## **Summary of Submissions:**

## **NO. 109 (LOT 100) PALMERSTON STREET, PERTH RESPONSE TO SUBMISSION – FOUR (4) GROUPED DWELLINGS**

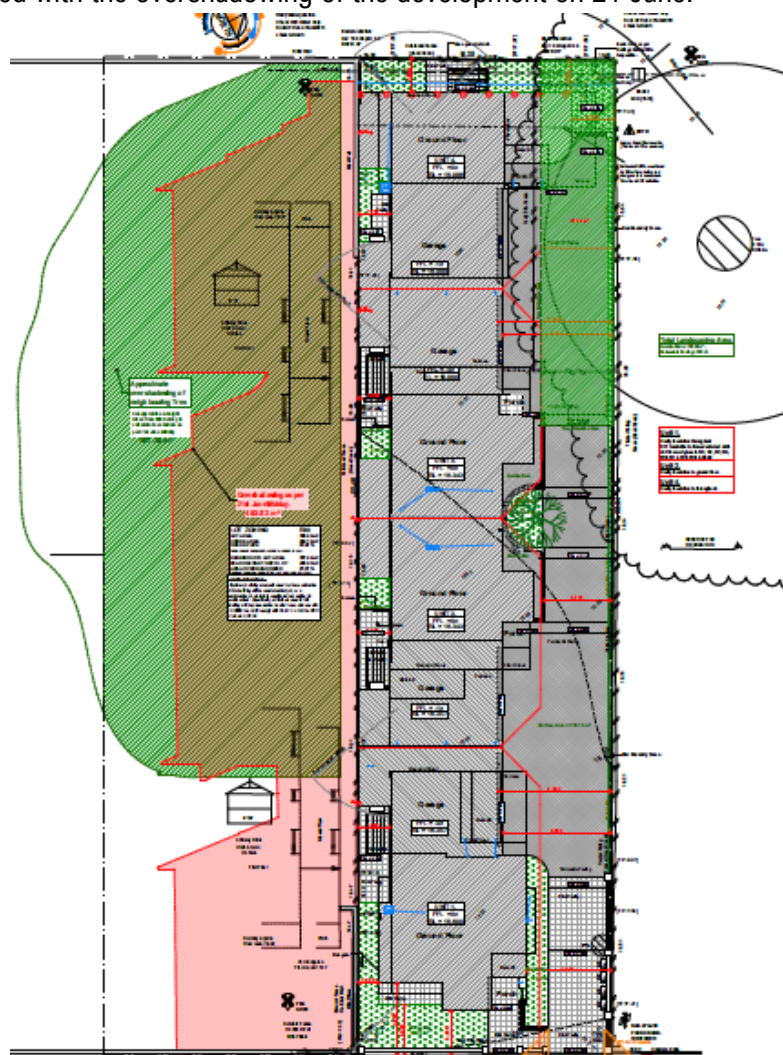
It is well established that the R-Codes Vol. 1 requires an assessment of any new development's overshadowing impact on the shortest day of the year, being June 21. While the exact date the June Nearmap image was taken; it does provide evidence that during the winter solstice the subject site and the adjoining site are severely impacted by overshadowing as a result of the Fig Tree to the north.

In reviewing the prevailing lot configuration of the locality it is preferable to locate any new development on the subject site, as close as possible to the northern boundary. However this siting requirement

competes with the desire to provide adequate separation between new buildings and the Fig Tree (a tree protection zone to protect the roots and provide for adequate infiltration to the root system); and as such a conflict arises.

Notwithstanding, a closer look at the existing overshadowing situation also provides an opportunity to appropriately site a portion of the built form in the existing overshadowing pocket that occurs as a result of the Fig Tree. This is because any new buildings proposed in the existing overshadowing area will not exacerbate the winter overshadowing scenario that exists as a result of the Fig Tree.

- The form of the proposed development is entirely acceptable on the basis that it responds to the constraints that are unique to this property discussed above.
- It is unreasonable and disproportionate to request that the design should “*protect solar access for neighbouring properties*” (Clause 5.4.2 of the R-Codes Vol. 1), when the Fig Tree causes such a significant overshadowing contribution to No. 107 Palmerston Street in its own right – refer to below image taken from the development plans which depicts the overshadowing of the Fig Tree (shaded green) compared with the overshadowing of the development on 21 June.

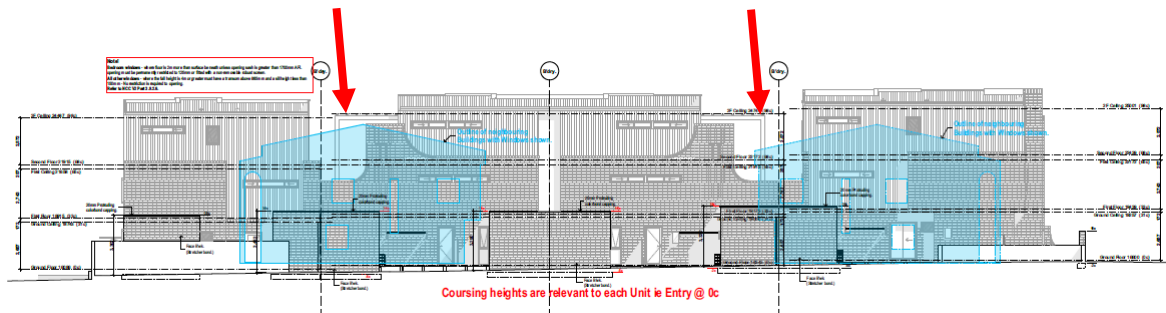
- The proposed design seeks to break-up the built form (as depicted in the development plan elevations) that were inserted to reduce the Outdoor Living Areas adjoining the properties to the south that is overshadowed by the Fig Tree during winter. Additionally, this design feature was requested by the City's Design Review Plan. The below image depicts the location of the spacing/articulation, where light and natural ventilation can be provided to the units to the south.

- The overall design also seeks to break-up the proposed built form through the use of meaningful articulations and spacing between the dwellings. This allows northern sunlight to filter through to the properties to the south at No. 107 Palmerston Street, particularly as it is clear that sunlight will be able to pass through to some of the major openings associated with the buildings to the south.
